URBAN UNION

**Master Use Permit
Recommendation Packet**

Project #3015947

March 26, 2014

NORTHEAST CORNER CONDITION

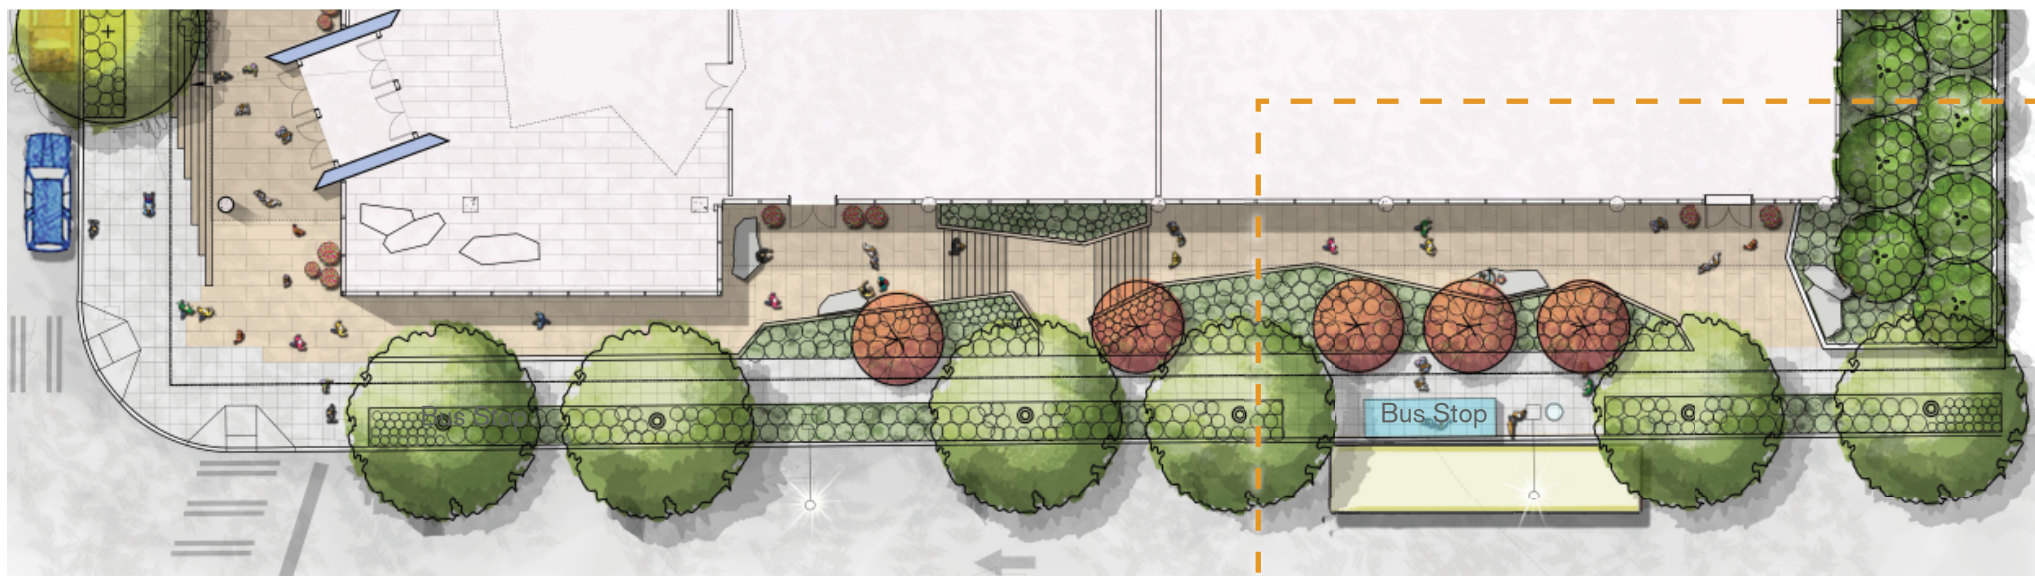
- a. The west side of Fairview on this block will experience a high level of pedestrian traffic for people accessing the intersection to Lake Union on the north end of the block. The Fairview Ave N. façade should be treated for pedestrian comfort and should be designed to provide eyes on the street near the adjacent bus stop. (A- 2, A-4, D-1, D-

- b. Overhead weather protection should be of sufficient width to provide adequate protection for pedestrians on Fairview Ave N. (A-2, D-1)

RESPONSE: The Fairview façade will be very transparent, and canopies will be provided at the building face. Planters with multiple openings will soften the ground plane and allow pedestrians to circulate freely between the sidewalk and the building face. The design encourages users to flow off the sidewalk and hug the building face under the canopy cover.

RESPONSE: As noted in the item above, metal and glass canopies between six and eight feet in width will be provided along the majority of the Fairview Avenue façade.

Fairview Ave N. Street Level Plan

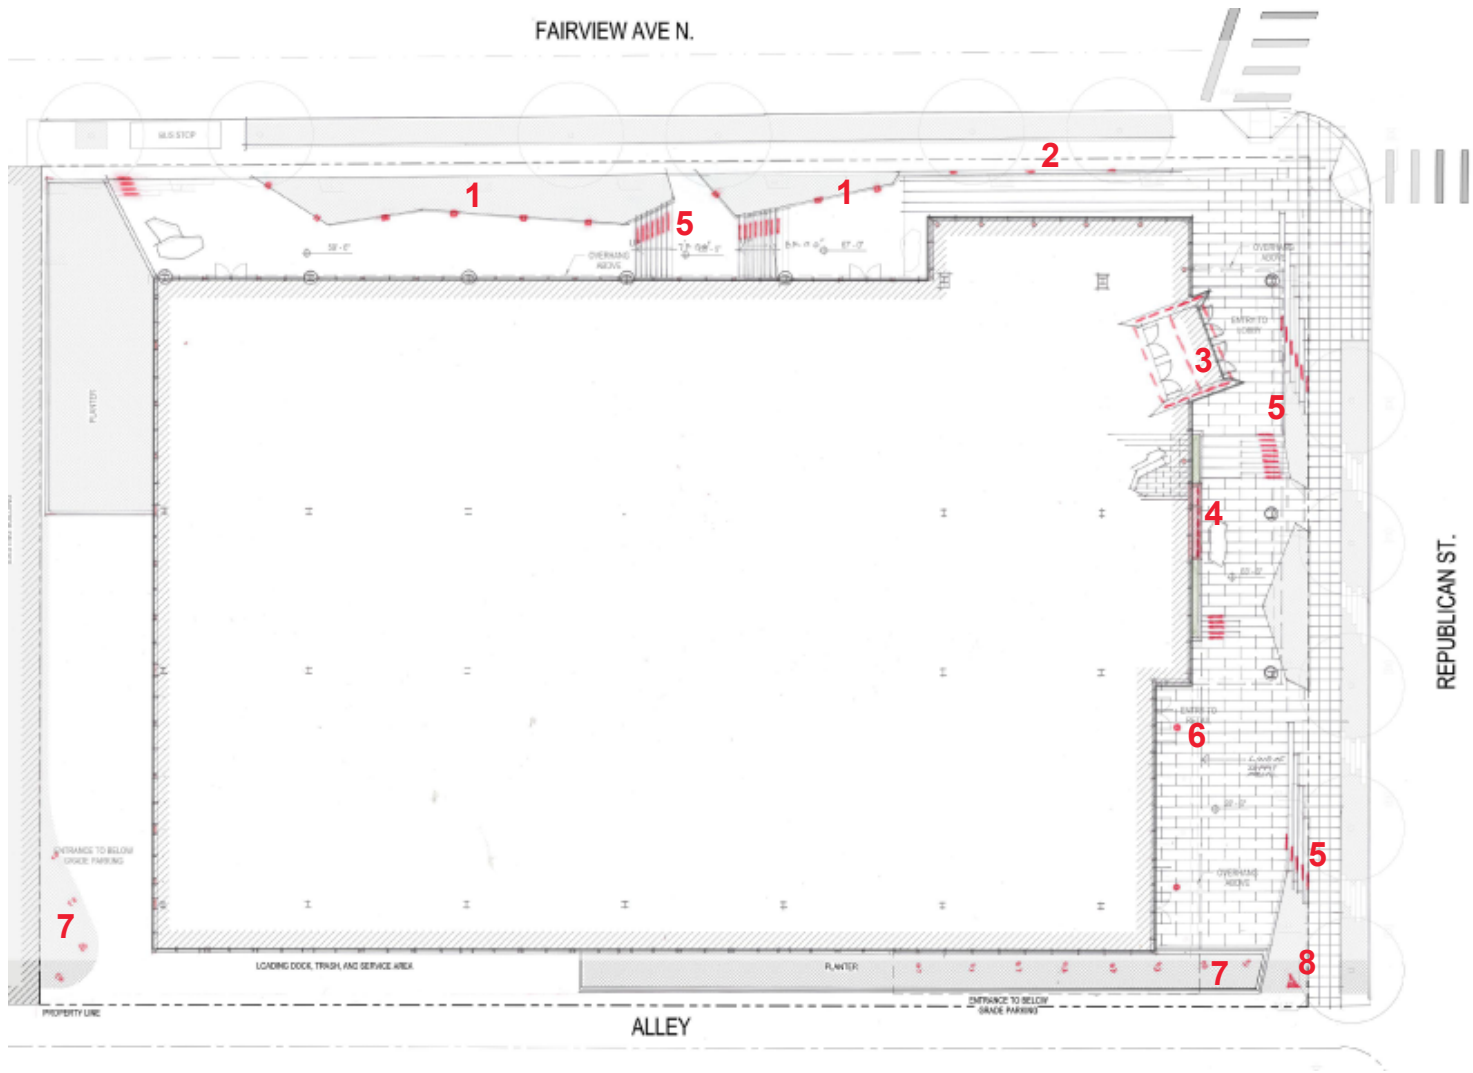
- c. The applicant should work with King County Metro to integrate the bus stop into the proposed development, possibly using leaning rails or seating and overhead weather protection on the building façade. (A-1, A-2, C-2, D-1)

RESPONSE: The bus shelter is proposed to be relocated in the right of way slightly north of its existing location to allow for a continuation of the street tree pattern on Fairview. Open walkways on either side will provide for ease of transition between the sidewalk and plaza area, and will reduce the chance of blocking access to the building face.

MINIMUM SETBACK ANALYSIS

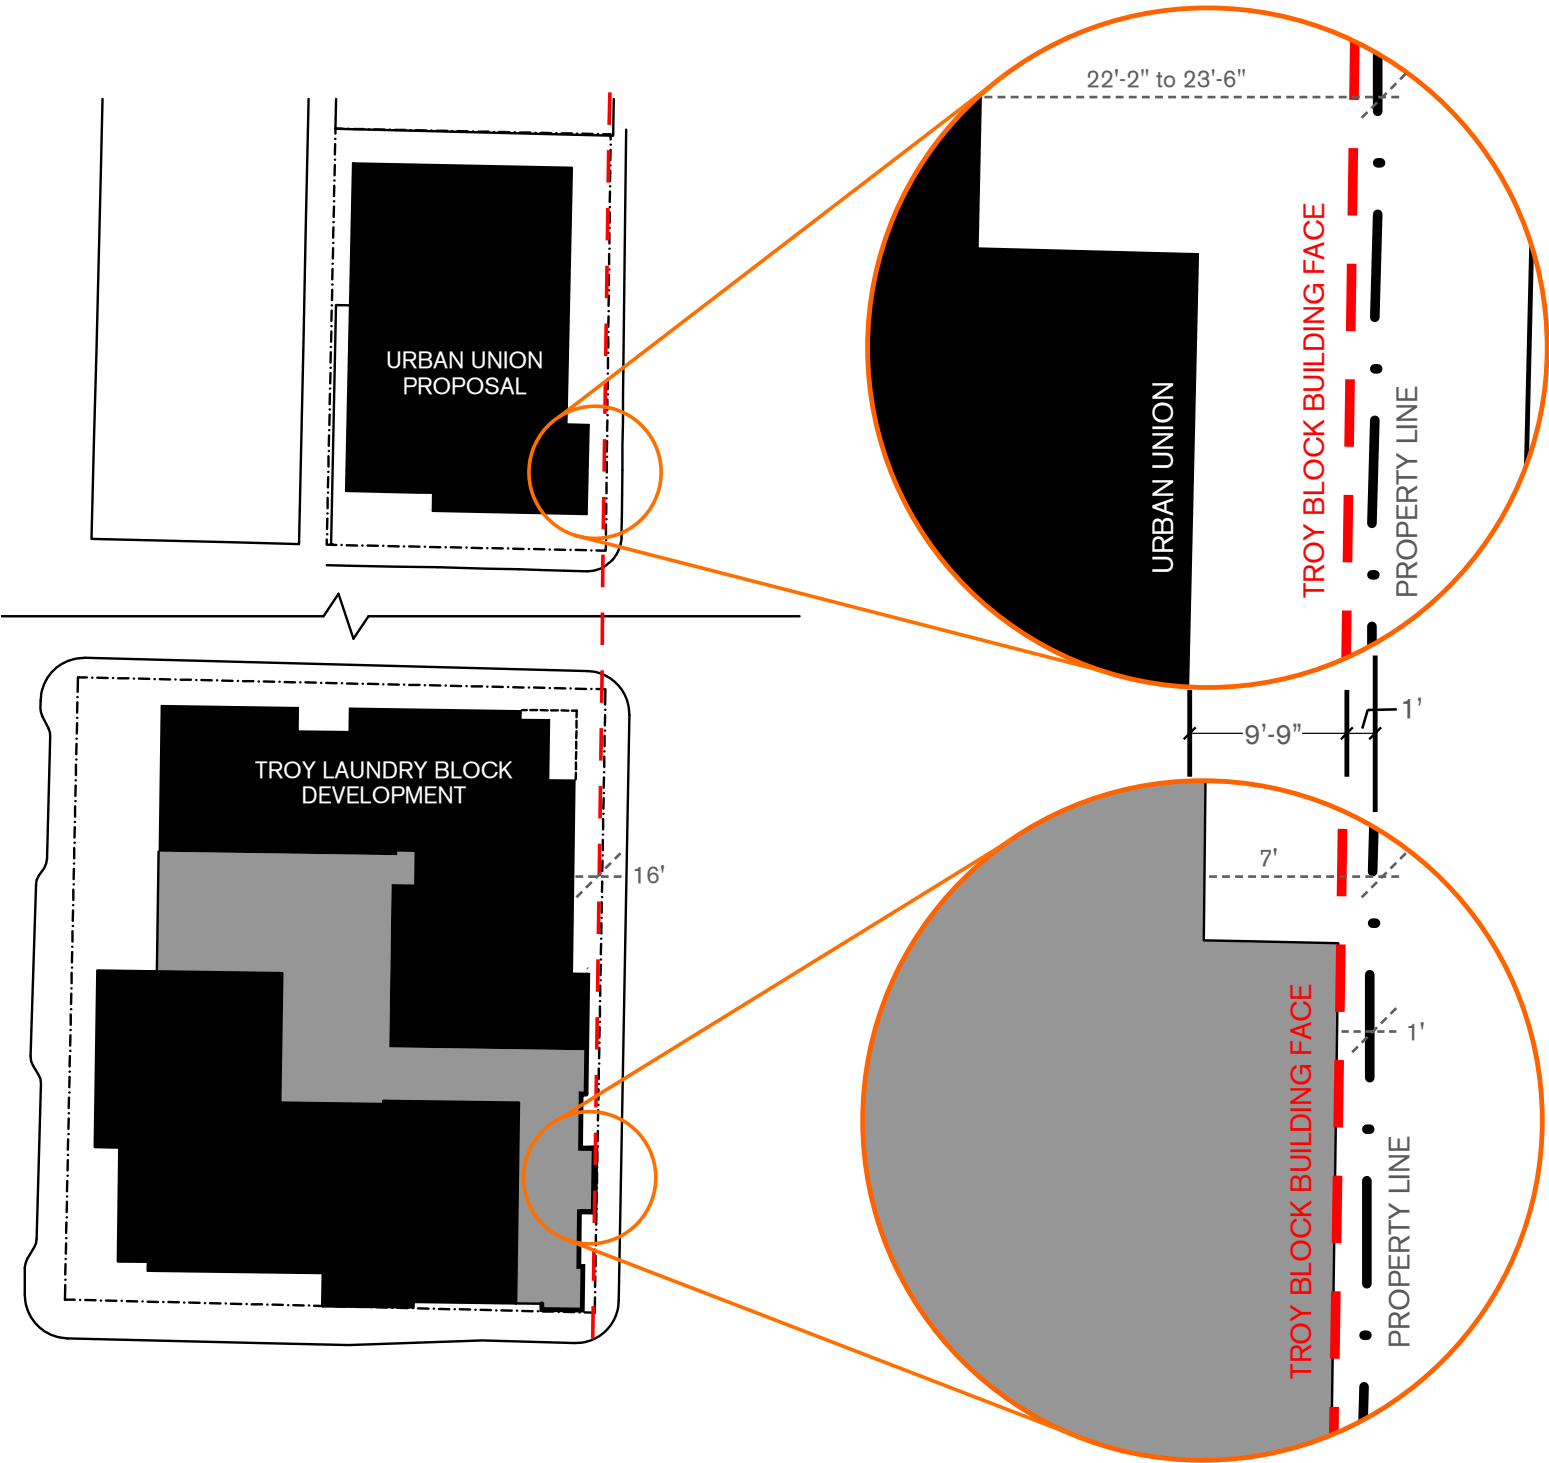
b. The Board would like to see how the proposed east setback and façade relate to nearby proposed development on the west side of Fairview Ave N, including the Troy Block development (MUP 3012675). In response to nearby context and potential pedestrian views, the east façade of the proposed development should at least maintain the same setback as the upper levels of the Troy Block development. (A-1, A-2, C-1)

RESPONSE: See the attached illustrations on pages 4 and 5 of the MUP Supplemental Package showing the relationship of the proposed design to the proposed Troy Laundry block design. Because the podium levels of the two projects have the most effect on the pedestrian views, the illustrations compare the podium levels of the two buildings. The podium level of the Troy Laundry block is comprised of the retained historical façade, (55% of the length), and new construction (45%). At the historical façade one 38 foot portion extends to within one foot from the property line, with the remainder set back approximately seven feet from the property line. To the north, the predominant portion of the new façade of the podium is set back approximately 16 feet from the property line with the north most bay set back an additional 16 feet.

As noted in item 3-a-ii above, the primary podium façade of our proposal is set back between 22'-2" and 23'-6" from the property line, and the furthest projection is 10'-9" from the property line, 9'-9" farther than the furthest projection of the podium level of the Troy Laundry project.

The following exhibits demonstrate the relationship between the setbacks for the Urban Union proposal and the Troy Laundry Block development. As this diagram illustrates, the Urban Union proposal is set back 9'-9" further than the Troy Laundry Block development.

Summer view with vertical element

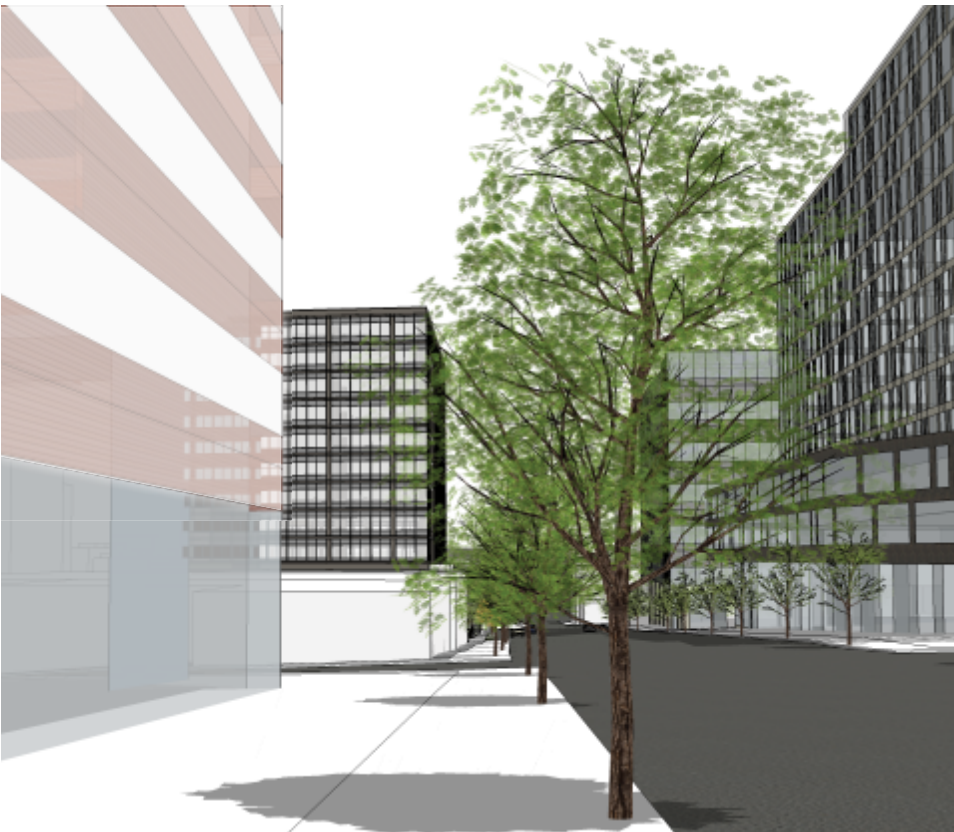
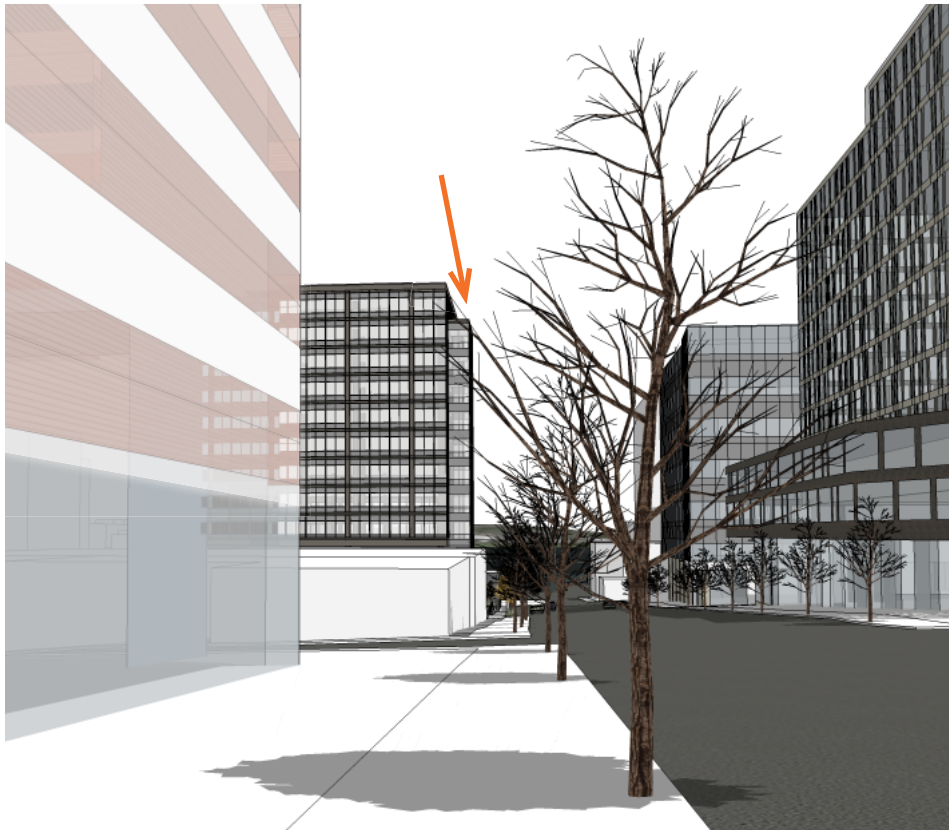
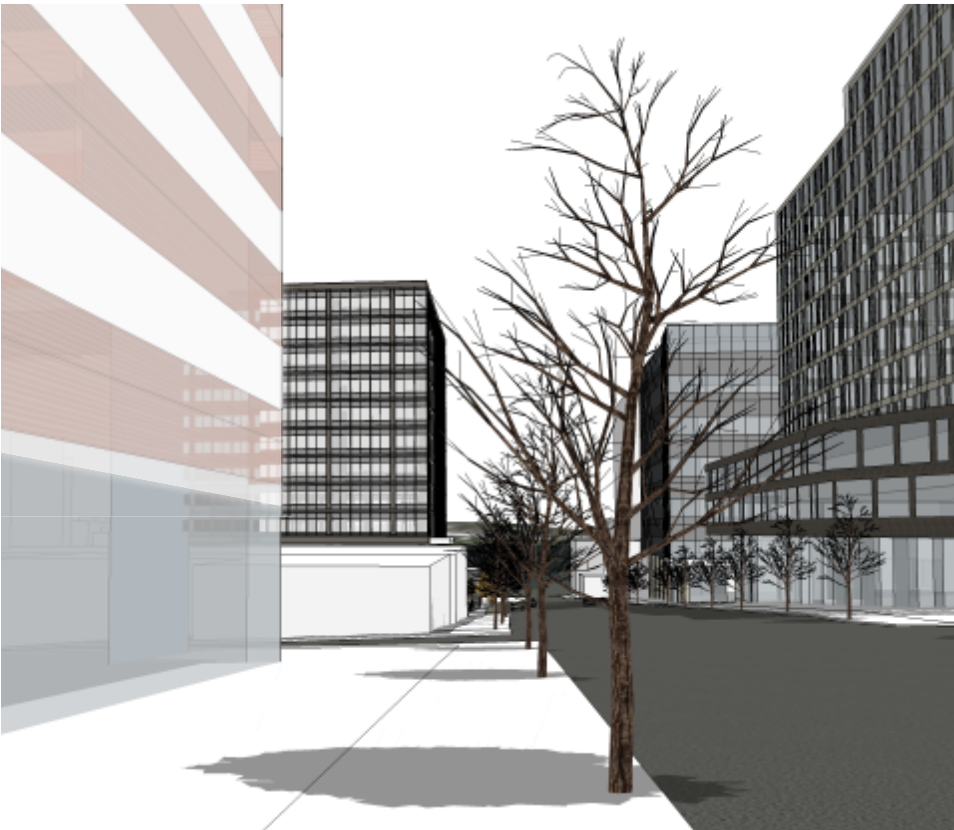
- a. The Board noted that the extension of the building façade toward the east property line may intrude further into the pedestrian view potential along Fairview Ave. The Board recommended that the massing should be located to minimize impacts to potential pedestrian views along Fairview Ave N. (A-1, A-2, C-1)
- i. The Board suggested that the applicant could push the building further to the alley, in favor of setting back from Fairview Ave.

- ii. The Board also offered that the building bay could begin approximately 30' above grade, which might help to preserve pedestrian views along Fairview Ave N.

RESPONSE: The entire building has been moved several feet towards the alley, to the maximum amount possible to prevent the garage level from extending past the two foot alley set back. See item 3-a-ii, below.

RESPONSE: The design team has investigated this option, and concluded that the integration of the lobby/great room expression with the vertical bay element is an important design expression that makes both elements stronger and more unified, and is central to the goal of achieving architectural concept and consistency (Design Guideline C-2). Therefore, we propose to keep the lower portion of the bay element, so it extends from the lobby level through level 11.

The predominant portion (75%) of the base of our proposal is set back between 22'-2" and 23'-6" from the property line, while the building bay is set back between 10'-9" and 11'-3" (due to the property line angle). The required set back per zoning at the podium level (up to 65 feet) is zero feet, with a 2.5 foot pedestrian easement at the sidewalk level. At the bay, the proposed design exceeds the most restrictive zoning set back by 8'-3", while maintaining a high degree of transparency.

SOUTHEAST PERSPECTIVE

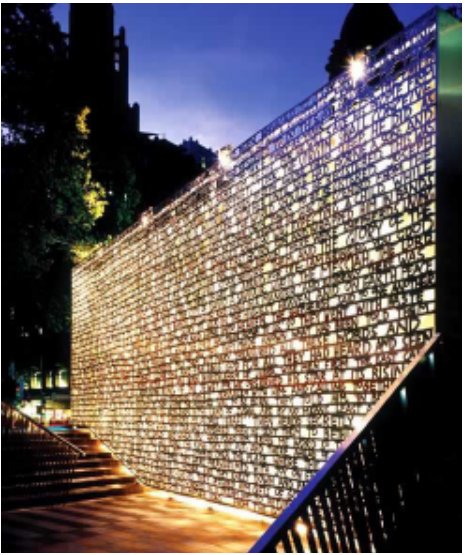
c. The Board supported the modulation/articulation of the east façade, and recommended that the east façade be modulated in a way that preserves potential pedestrian views along Fairview Ave N. (A-1, A-2, B-1, C-2)

RESPONSE: The location of the modulation (bay) to the south end of the building serves to lessen its impact on views to Lake Union as compared to a similar bay placed further to the north. As stated in item 3-a-ii, the podium levels of the bay exceed the required setback by over eight feet, and is constructed primarily of glass. It also exceeds the furthest projection of the podium at the Troy Laundry by 9'-9".
